CORE COMPLIANCE TESTING SITE PLAN

SP# 14-22

STAFF REPORT

Re: Town of Hudson Planning Board Review Core Compliance Addition Site Plan, 79 River Road Tax Map 251 Lot 8; Acct. #1350-546 Reference No. 20030249.2240

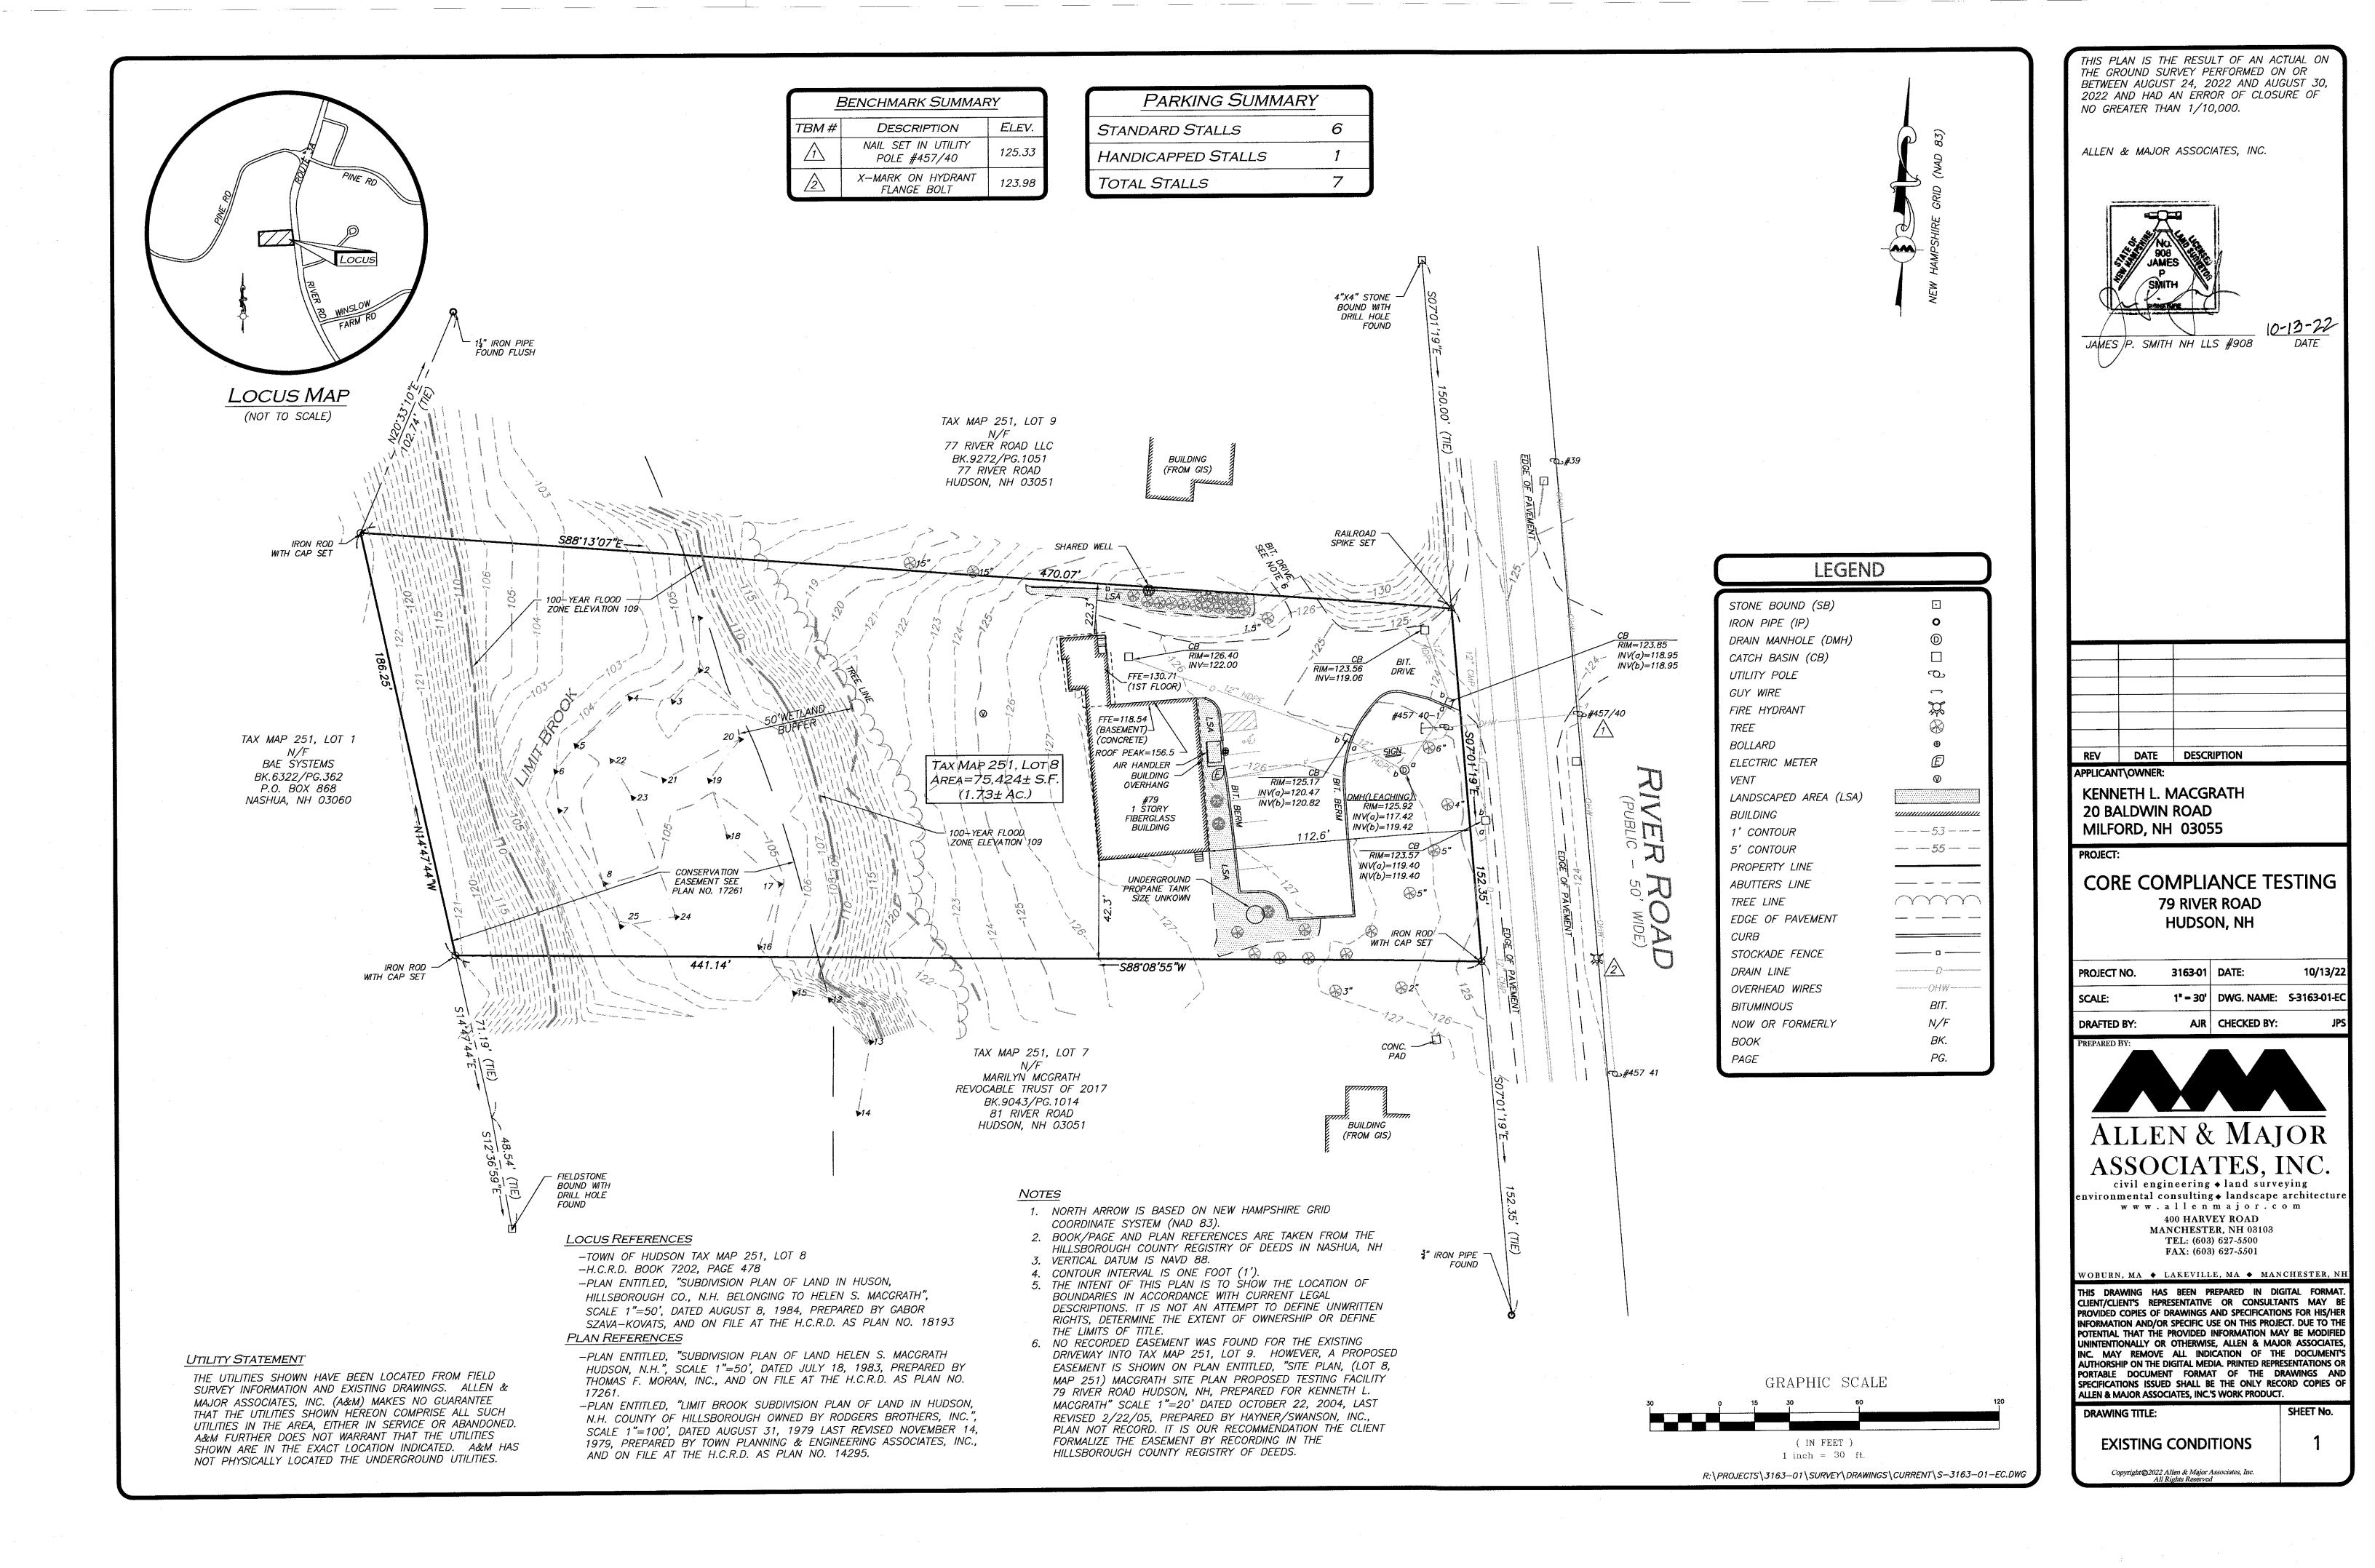
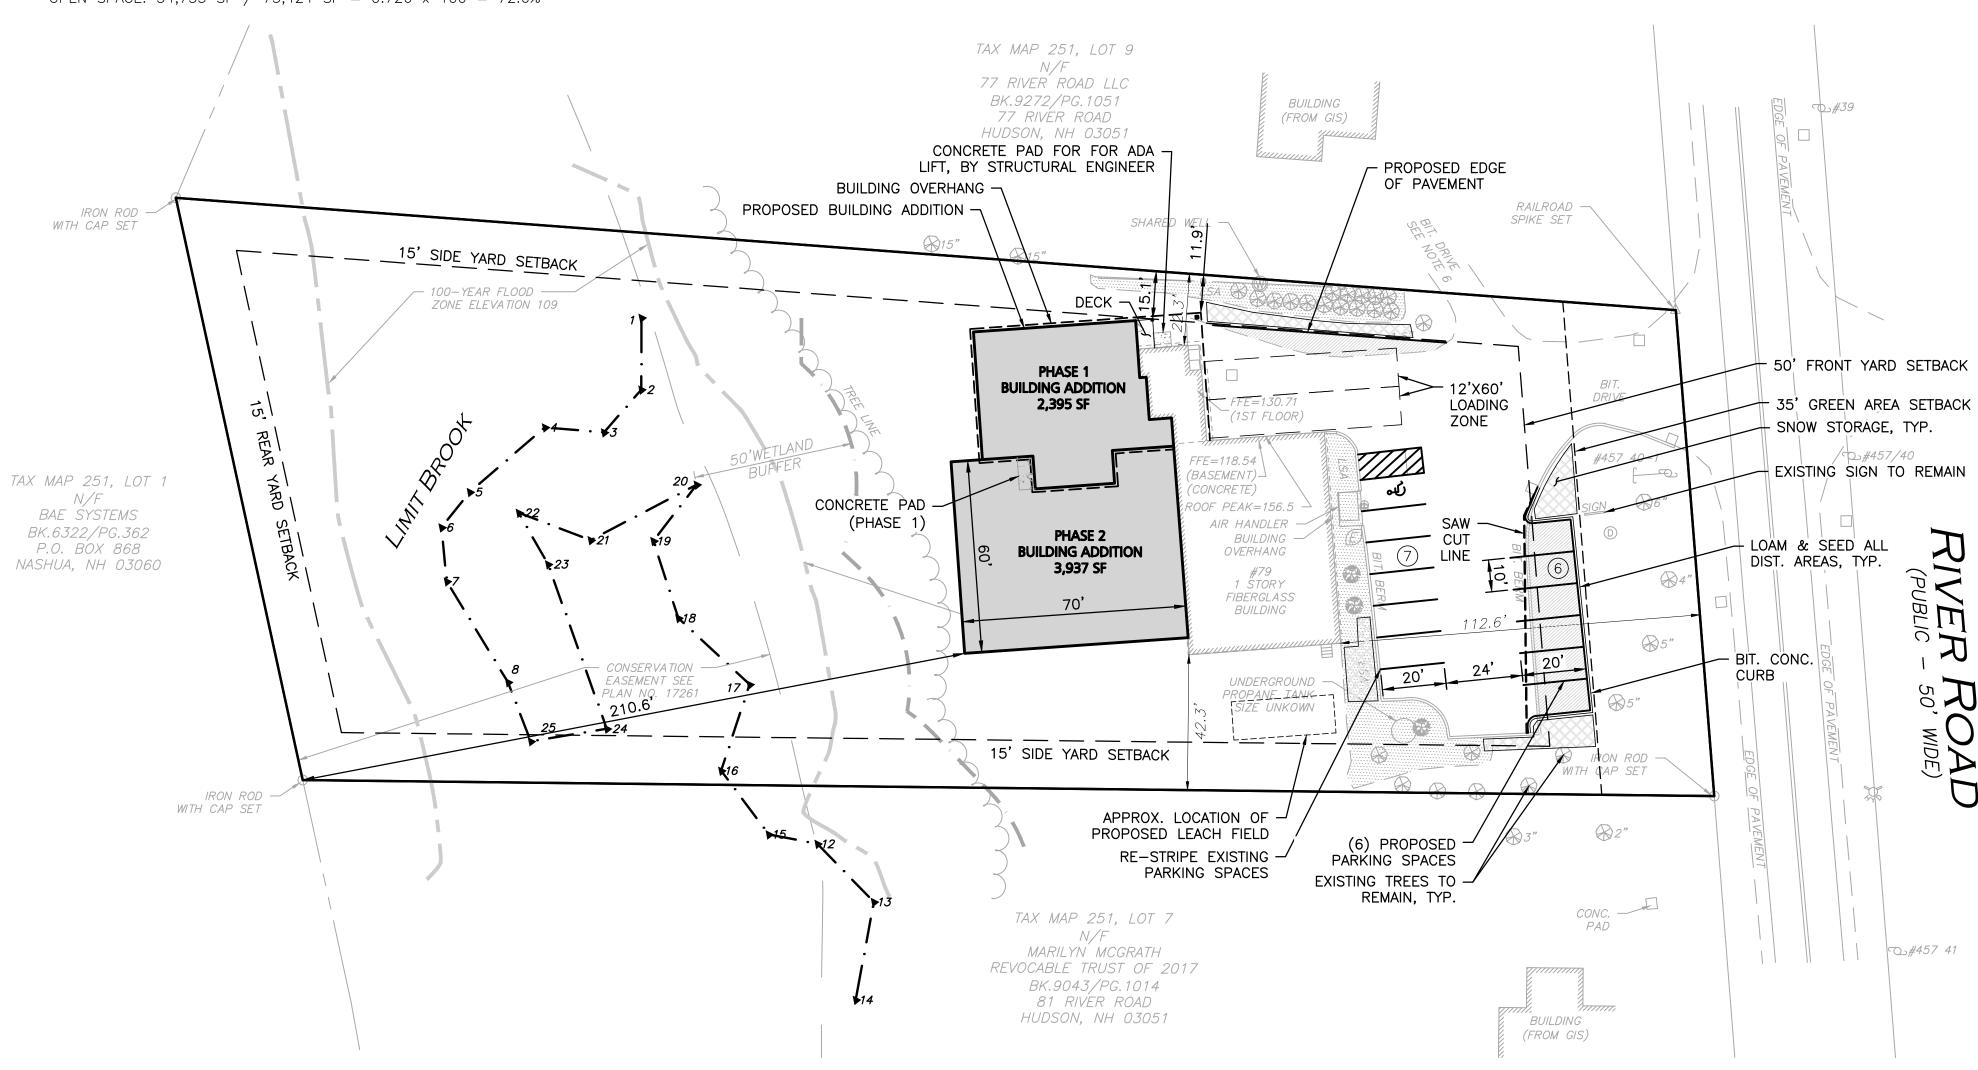
- b. HR 275-6.I. The scope of this review does not include the adequacy of any fire protection provisions for the proposed building addition. The applicant has not shown the existing water connection to the building from the shared well on the plan set. We note that there is a fire hydrant across from the lot on River Road.

- c. HR 275-6.T. The applicant is not proposing any offsite improvements on the plan set.
- d. HR 275-8.C.(2)(g) and Zoning Ordinance (ZO) 334-15.A. The applicant has provided parking calculations on the plan set and noted that nine parking spaces are required for the industrial use using the number of employees and that 13 spaces are provided. We note that the applicant has not provided calculations based on the total square footage of the building (1 space per 600 sf formula) to verify which is larger as required by the Regulation. Based on our measurements, it appears that the square footage method would

require 17 spaces and therefore the applicant should review the need for a waiver.

- a. HR 276-11.1.B.(4). The applicant should add the approval block to the Existing Conditions Plan.
- b. HR 276-11.1.B.(6). The applicant should add the owner's signature to the plan set.
- c. HR 276-11.1.B.(12).(a). The applicant has requested a waiver from the residential use setback.
- d. HR 276-11.1.B.(13). The applicant has noted the existing sign is to remain.
- e. HR 276-11.1.B.(16). The applicant has not provided locations of driveways and parking areas withing 200 feet of the site.
- f. HR 276-11.1.B.(20). The applicant has not provided the size and height of the existing building on the plan set.
- g. HR 276-11.1.B.(23). The applicant has not noted any pertinent highway projects on the plan set.

a. HR 193.10. The applicant has not proposed any changes to the existing driveway. The site will continue to have one driveway onto River Road. This driveway also provides access to lot 9. We note no easement is shown on the plans for this access. The applicant has noted that an easement was not found but would be recommended.

- a. HR 275-9.E. The applicant has shown the approximate location of the proposed leach field but has not provided any design information or shown the existing leach field/septic tank on the site. There is a vent shown on the Existing Conditions plan which may be related to the existing septic system.
- b. HR 275-9.E. The applicant has shown the location of a shared well onsite but has not provided any information on who shares the well, shown the protective well radius, provided any flow calculations, or provided any easement information. The applicant

should clarify if the shared well is the water source for this site or are they connected to municipal water via River Road (existing hydrant is shown but water piping is not).

C-102

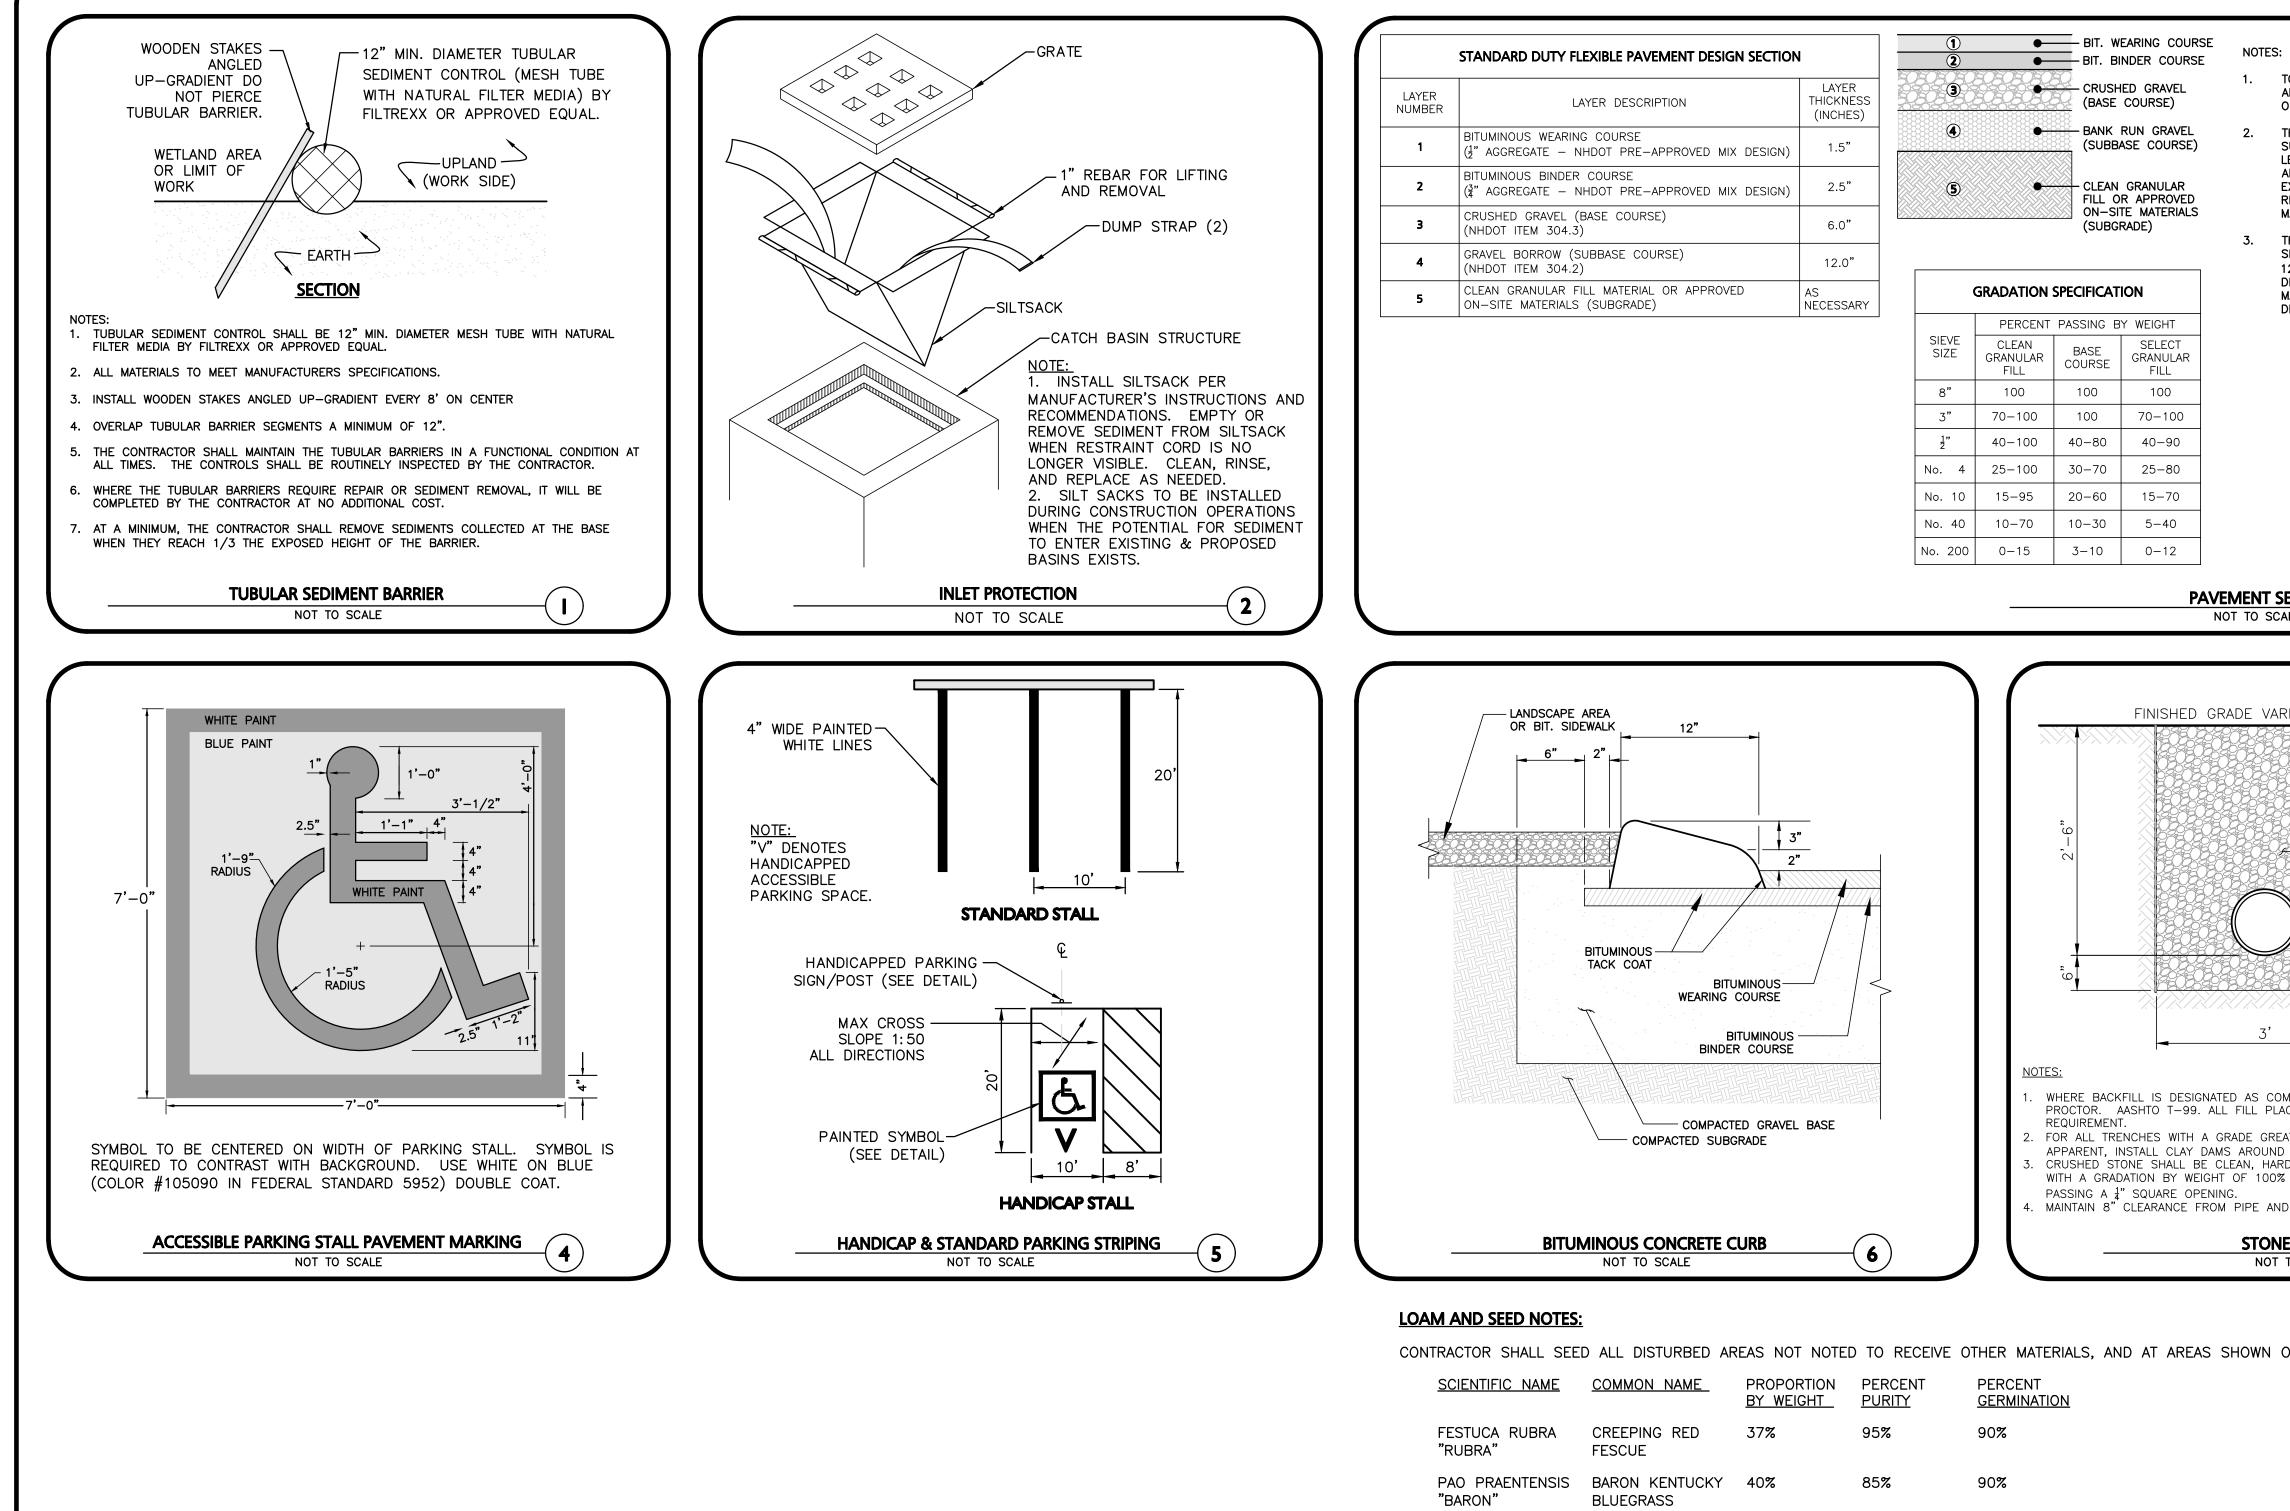
- a. HR 290-3.A.3. Although the project does not disturb the 20,000 square foot minimum criteria to trigger the Hudson Stormwater Management Regulations, the project does qualify to disturb a "Critical Area" criteria. The project disturbs more than 25' of length on slopes greater than 10%, specifically in the 15% range. Many items of the HSMR Section 290 are not currently supplied and are required for full submittal review. See comments below.

- b. HR 290-5.A.1. & 3. The applicant should provide language in the Drainage Analysis Report, stating if and how low impact development (LID) strategies for stormwater runoff were evaluated for this project.

- c. HR 290-5.A.4. & 5.A.9. The applicant should provide the GRV excel spreadsheet calculation to the Stormwater Management Report.
- d. HR 290-5.A.4. & 5.A.9. We note a test pit for the existing building was performed 18 years ago in 2004. The applicant should provide test pit information including ESHWT within the location of the proposed drip edge, to verify that soils and ESHWT are similar.

- e. HR 290-5.A.4. & 5.A.9. The applicant should provide treatment criteria for the stormwater runoff prior to infiltration.
- f. HR 290-5.A.12. The applicant should provide a detailed Inspection and Maintenance checklist, listing individual BMP practices. This ensures each practice achieves appropriate inspection and maintenance and functions as designed.

- g. HR 290-5.A.12. The applicant should explore the option of gutters and infiltration not exposed to the surface (subsurface wrapped in fabric). As drip edges are prone to clogging with leaves and grass clippings, the owner must be fully aware of the long-term requirements to prolonging the life of this stormwater feature.

- h. HR 290-5.A.12. The applicant should note the requirement to inspect the existing leaching catch basin for proper functionality, and maintenance of the catch basin may be required.
